International application No.
PCT/EP00/07353

INTERNATIONAL PRELIMINARY EXAMINATION REPORT

1. The invention concerns an automatic valve intended for installation in the inlet of a thermostatic mixing device.

Fig-1

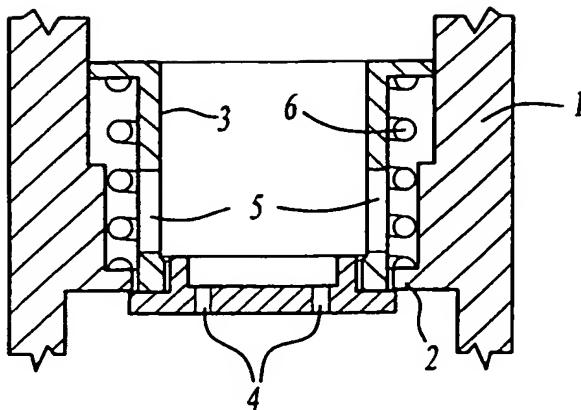
1. Claim 7 states that when the valve is in the first position (ie. closed), the small opening 4 is "up the line" from the seat 2. Looking at figure 1, this appears not to be the case, as the openings 4 are always downstream from the seat 2.
2. Further, claim 7 states that the small opening 4 only becomes pervious when the cursor undergoes a minor shift towards its second (open) position. Looking at figure 1, this also appears not to be the case, as the openings 4 are always open, even when the valve is resting on the seat 2.
